Illustrated Parts List - IPL Update

395XP, 395XP EPA

1. Incorporation of new Hose clamps with Torx grip.
Reason: Replacement for Hose clamp with Phillips grip.

1. Carburetor & Air filter

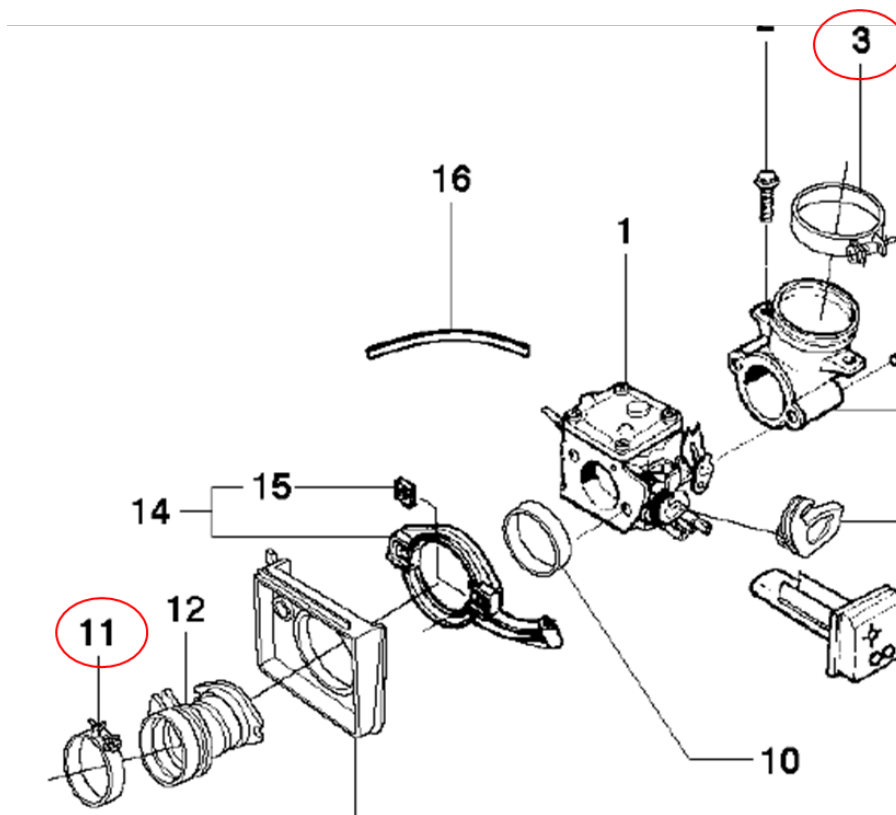
Hose clamp 505 28 33-15 replaces Hose clamp 505 28 33-05 (pos. 3).

Hose clamp 505 28 33-13 replaces Hose clamp 505 28 33-03 (pos. 11).
